Groundwater Transfer Review Summary Form

Transfer/PA # T- 13749

Application: T-13749

Applicant Name: Big Falls Ranch

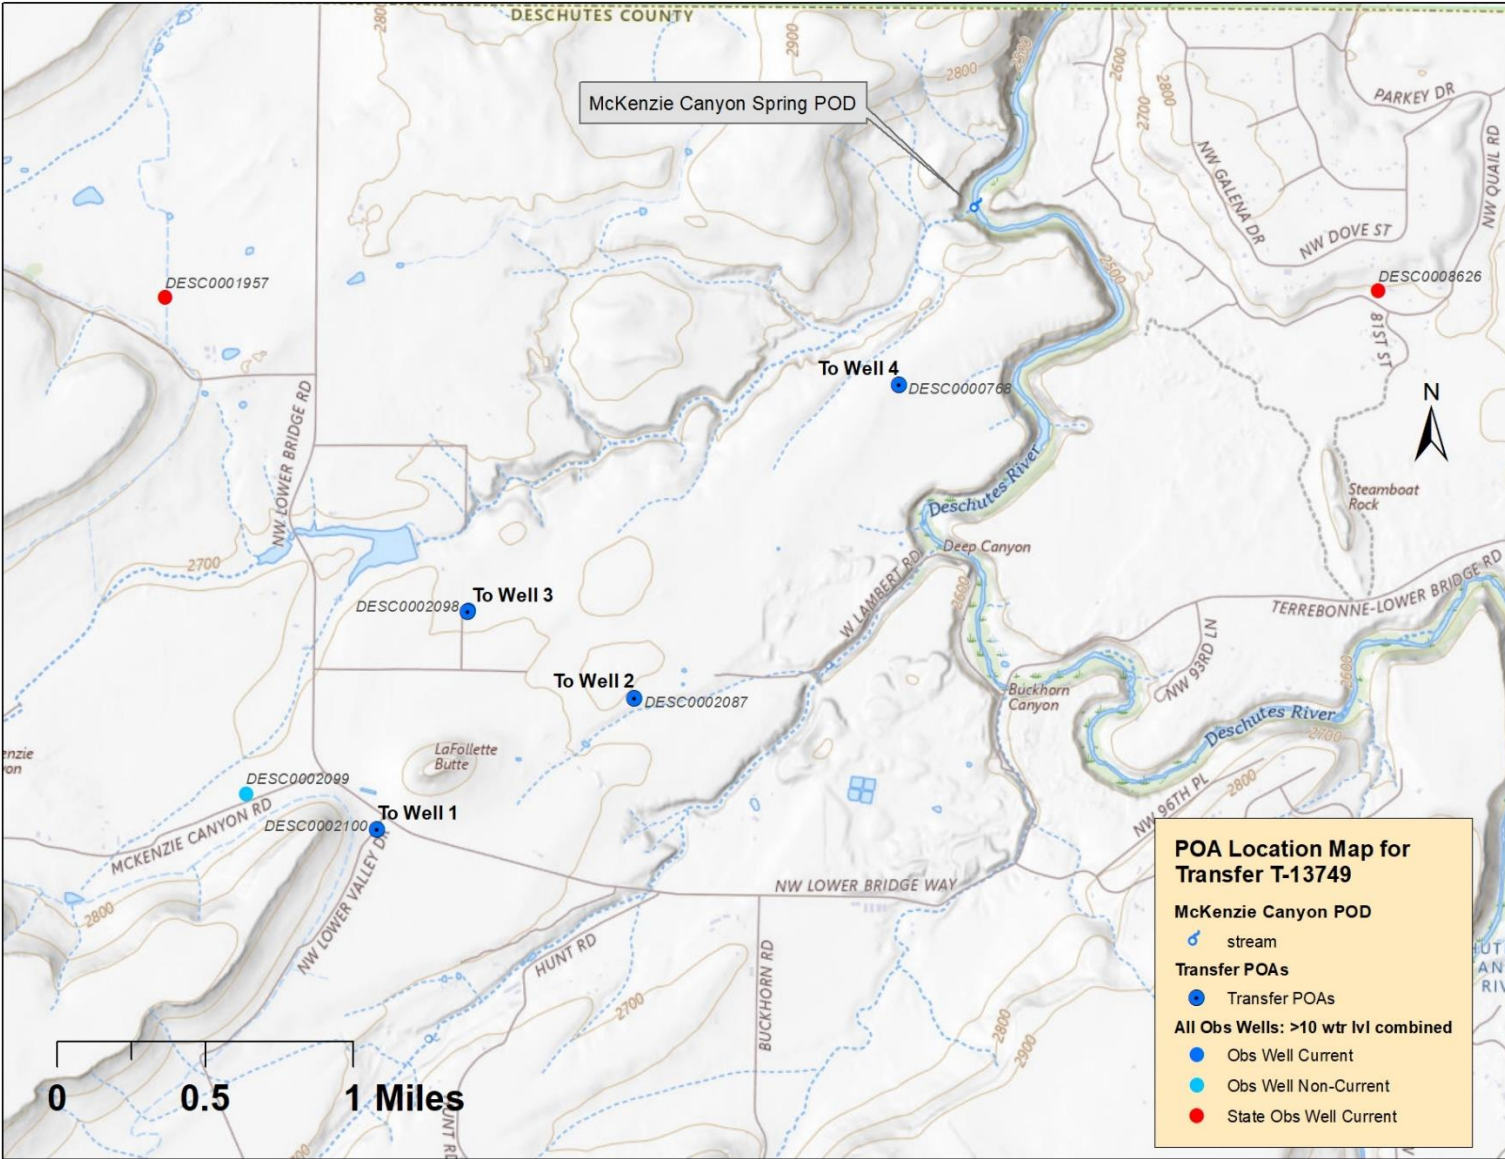
2. Will the proposed POA develop the same aquifer (source) as the existing authorized POA?
☒ Yes ☐ No Comments: The Deschutes regional aquifer begins to discharge to surface water in the Lower Bridge, which includes the McKenzie Canyon spring POD at an approximate elevation of 2440 feet amsl. The applicant's wells all produce groundwater from the Deschutes regional aquifer and have similar water level elevations.
